Flood Control Project Maintenance
Levee Inspections

Fall 2016 Levee Maintenance Deficiency Summary Report

Levee Inspection Report By Mile - Fall 2016

Sutter Maintenance Yard Maintenance Area 0007

Photo 2 of 2 : FA_2016_MA0007_200_42_20160906_00007.jpg

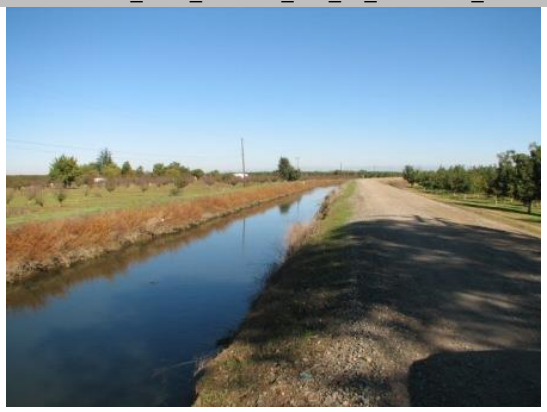
E1 : Note and monitor erosion site.

Erosion along landward levee slope due to agricultural ditch.

Agricultural ditch landside slope and toe.

Photo 1 of 2 : UCIP_FA_2016_48005_65904.jpg

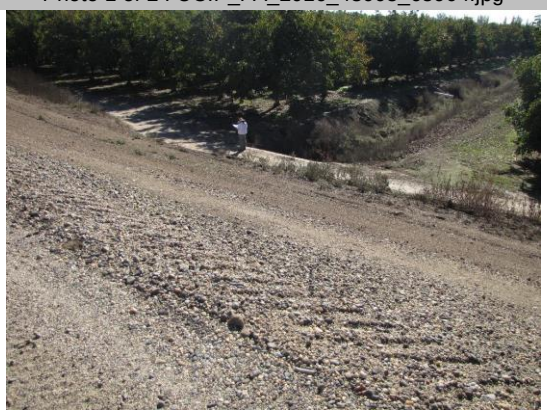
FS_ID:48005
DS_ID:16922
EP_NO: N/A
Repair Type: Non-Urgent
Crossing Status: Found
UCIP Comments: 5/16/2016 Feather River West Levee Improvement Project--Levee currently under construction. Crossing, referenced as STA 1961+03, will be removed as indicated in the project Plans for Construction of Feather River West Levee Project, Project Area A, Feather River West Levee Improvement Plans, Sta 1765+00 to 2368+26, Volume 3 of 5. The 2-60 inch pipes will be replaced with a single 36-inch pipe.6/10/2015 Sediment still blocking the flap gates on WS. LS inlet ebing overgrown by vegetation in the ditch.12/29/2014 Same as last inspection.5/19/2014 Same as last inspection.11/7/2013 Same as last inspection.5/13/2013 SBFCA project recommends relacing in accordance with title 23.5/10/2013 Same as last inspection.11/5/2012 Sediment blocking flap gates on WS--need to clear sediment. This crossing was listed in the USACE Periodic Inspection as ID# USACE_CESPK_MA07_2010_a_0180 no issues reported.

FIELD_STRUCT_DESC: 1 of 2: 60-inch corrugated metal drainage pipe (downstream pipe) through the levee, 23.4 feet below the crown. Concrete headwalls on both the waterside (WS) and landside (LS) ends. Flap gate on the WS end. Ditch at WS outlet. [Additional Reference(s): DWR Levee Log, 2005. USACE Sacramento O&M Manual 152, March 1957 (Station 195+80)]
FS Date: 5/16/2016 10:29:00 AM

View of WS. Concrete headwall located at levee toe.

Photo 1 of 2 : UCIP_FA_2016_48006_65911.jpg

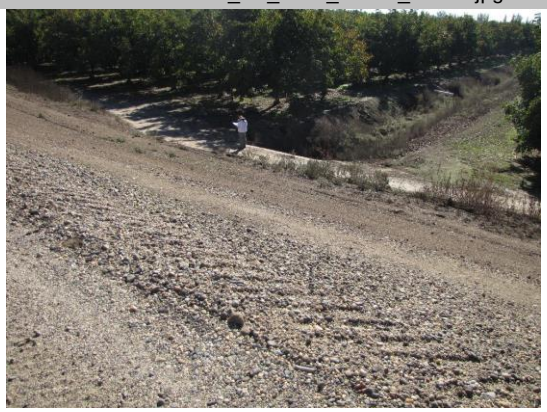
FS_ID:48006
DS_ID:17013
EP_NO: N/A
Repair Type: Non-Urgent
Crossing Status: Found
UCIP Comments: 5/16/2016 Feather River West Levee Improvement Project--Levee currently under construction. Crossing, referenced as STA 1961+10, will be removed as indicated in the project Plans for Construction of Feather River West Levee Project, Project Area A, Feather River West Levee Improvement Plans, Sta 1765+00 to 2368+26, Volume 3 of 5. The 2-60 inch pipes will be replaced with a single 36-inch pipe.6/10/2015 Sediment still blocking the flap gates on WS. LS inlet ebing overgrown by vegetation in the ditch.12/29/2014 Same as last inspection.5/19/2014 Same as last inspection.11/7/2013 Same as last inspection.5/13/2013 SBFCA project recommends relacing in accordance with title 23.5/10/2013 Same as last inspection.11/5/2012 Sediment blocking flap gate--need to remove sediment to make flap gates operational.
FIELD_STRUCT_DESC: 2 of 2: 60-inch corrugated metal drainage pipe (upstream pipe) through the levee, 23.4 feet below the crown. Concrete headwalls on both the waterside (WS) and landside (LS) ends. Flap gate on the WS end. Ditch located at WS outlet. (USACE O&M Manual, 1957) [Additional Reference(s): DWR Levee Log, 2005. USACE Sacramento O&M Manual 152, March 1957 (Station 195+80)]

View of WS with clear slope.

Photo 2 of 2 : UCIP_FA_2016_48007_65922.jpg

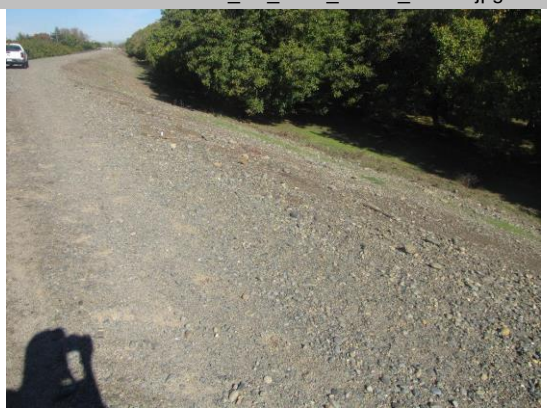
FS_ID:48007
DS_ID:16960
EP_NO: 17895
Repair Type: Non-Urgent
Crossing Status: Indicator Found
UCIP Comments: 5/16/2016 Feather River West Levee Improvement Project--Levee currently under construction. Crossing, referenced as STA 2084+03, will be removed and replaced as indicated in the project Plans for Construction of Feather River West Levee Project, Project Area A, Feather River West Levee Improvement Plans, Sta 1765+00 to 2368+26, Volume 3 of 5.6/10/2015 Minor erosin still present near air vent.12/30/2014 Same as last inspection.5/19/2014 Same as last inspection.11/7/2013 Same as last inspection.11/5/2012 localized erosion at air vent located on WS shoulder; this crossing appears to have leaking at the air vent--will need to determine reason for erosion at air vent (vehicles going over vent?); also recommend installing utility marker.
FIELD_STRUCT_DESC: 5-inch steel irrigation pipe through the right (west) bank levee at an unknown depth below the crown. Pipe connects to existing pipe within the overflow area of the Feather River. (Permit No. 17895, 2005 - John Kucek)

View of WS and levee crown looking upstream towards crossing.

Photo 2 of 2 : UCIP_FA_2016_47874_65937.jpg

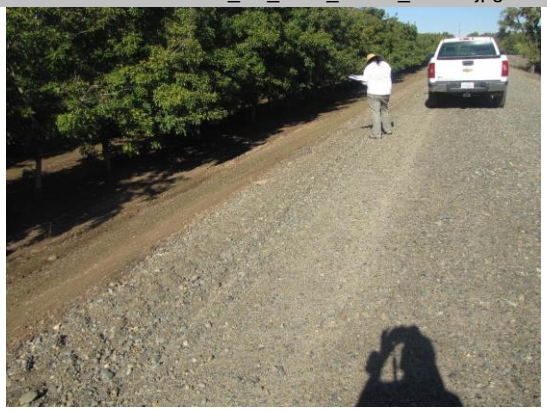
View of LS and levee crown looking upstream at crossing. Staff is standing adjacent to cavity located on LS shoulder.

Photo 1 of 1 : FA_2016_MA0007_200_45_20160906_00009.jpg

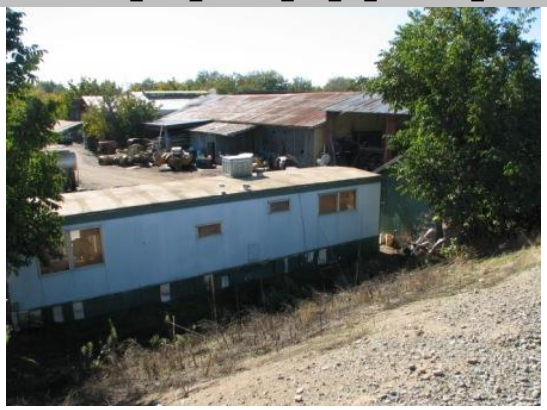
This photo shows a building at the landside toe.

Photo 2 of 2 : UCIP_FA_2016_47990_65945.jpg

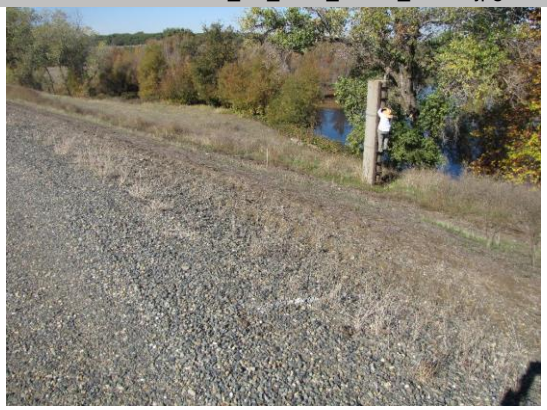
FS_ID:47990
DS_ID:16947
EP_NO: N/A
Repair Type: Non-Urgent
Crossing Status: Indicator Found
UCIP Comments: 5/16/2016 Feather River West Levee Improvement Project--Levee currently under construction. Crossing, referenced as STA 2201+87, will be removed and replaced as indicated in the project Plans for Construction of Feather River West Levee Project, Project Area A, Feather River West Levee Improvement Plans, Sta 1765+00 to 2368+26, Volume 3 of 5.6/11/2015 Abandoned crossing. SBFCA project recommends removal.12/30/2014 Same as last inspection.5/20/2014 Same as last inspection.11/7/2013 Same as last inspection.5/13/2013 SBFCA project recommends removal.5/10/2013 Same as last inspection.11/5/2012 Crossing appears to be abandoned; slide gate located inside concrete standpipe is buried with trash; no other features were visible during inspection. This crossing needs to be properly abandoned.
FIELD_STRUCT_DESC: *ABANDONED* 10-inch reinforced concrete encased steel irrigation pipe through the levee, 14.5 feet below the crown. Slide gate in 24-inch concrete standpipe at the waterside (WS) toe. [Additional Reference(s): DWR Levee Log, 2005. USACE Sacramento O&M Manual 152, March 1957 (Station 437+30)]

View of WS shoulder and slope looking upstream at crossing.

Photo 2 of 2 : UCIP_FA_2016_47993_65969.jpg

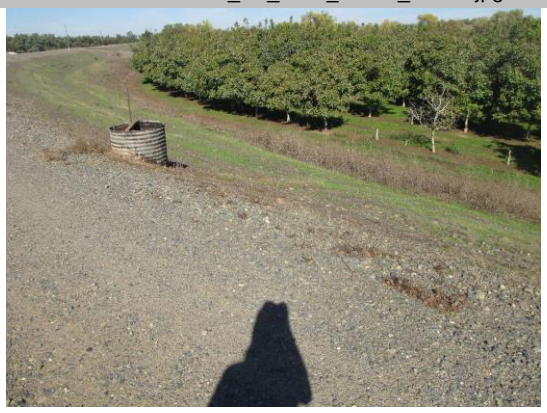
FS_ID:47993
DS_ID:16941
EP_NO: N/A
Repair Type: Non-Urgent
Crossing Status: Found
UCIP Comments: 5/16/2016 Feather River West Levee Improvement Project--Levee currently under construction. Crossing, referenced as STA 2256+71, will be removed as indicated in the project Plans for Construction of Feather River West Levee Project, Project Area A, Feather River West Levee Improvement Plans, Sta 1765+00 to 2368+26, Volume 3 of 5.6/11/2015 Same as last inspection.12/30/2014 Same as last inspection.5/20/2014 Same as last inspection.11/7/2013 Same as last inspection.5/13/2013 SBFCA project recommends removal.5/10/2013 Top cover has fallen down inside standpipe and may prevent gate from fully closing. Wheel to operate gate still missing.11/5/2012 WS-missing top cover of the CMP riser; debris inside CMP riser; wheel handle missing from slide gate. Unable to determine condition of slide gate face. LS-crossing not visible. This crossing was listed in the USACE Periodic Inspection as ID# USACE_CESPK_MA07_2010_a_0330 no issues reported. FIELD_STRUCT_DESC: 24-inch reinforced concrete encased corrugated metal irrigation pipe through the levee, 21 feet below the crown. Slide gate in 36-inch corrugated metal pipe (CMP) riser on the waterside (WS) slope. [Additional Reference(s): DWR Levee Log, 2005. USACE Sacramento O&M Manual 152, March 1957 (Station 490+50)]

View of WS looking upstream at crossing. CMP riser located on WS shoulder.

Photo 2 of 2 : UCIP_FA_2016_47958_65973.jpg

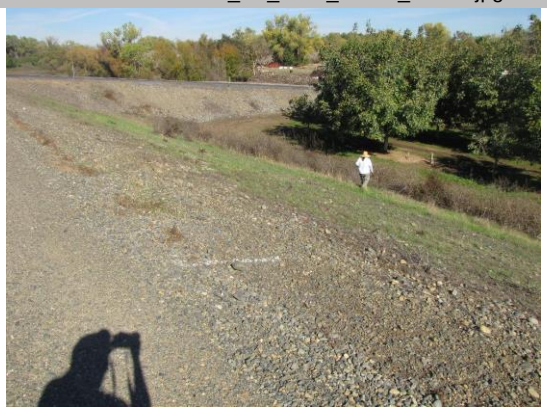
FS_ID:47958
DS_ID:16939
EP_NO: N/A
Repair Type: Non-Urgent
Crossing Status: Found
UCIP Comments: 5/16/2016 Feather River West Levee Improvement Project--Levee currently under construction. Crossing, referenced as STA 2260+55, will be removed as indicated in the project Plans for Construction of Feather River West Levee Project, Project Area A, Feather River West Levee Improvement Plans, Sta 1765+00 to 2368+26, Volume 3 of 5.6/11/2015 Both pipe ends are beeing overgrown by vegetation and are getting hard to inspect. Vegetation needs to be cleared away.12/30/2014 Same as last inspection.5/20/2014 Same as last inspection.11/7/2013 Same as last inspection.5/13/2013 SBFCA project recommends relacing in accordance with title 23.5/10/2013 Same as last inspection. Talking with farmer he said the pipe may be getting removed.11/5/2012 flash boards missing on LS. This crossing was listed in the USACE Periodic Inspection as ID# USACE_CESPK_MA07_2010_a_0332 no issues reported.

View of WS looking upstream at crossing.
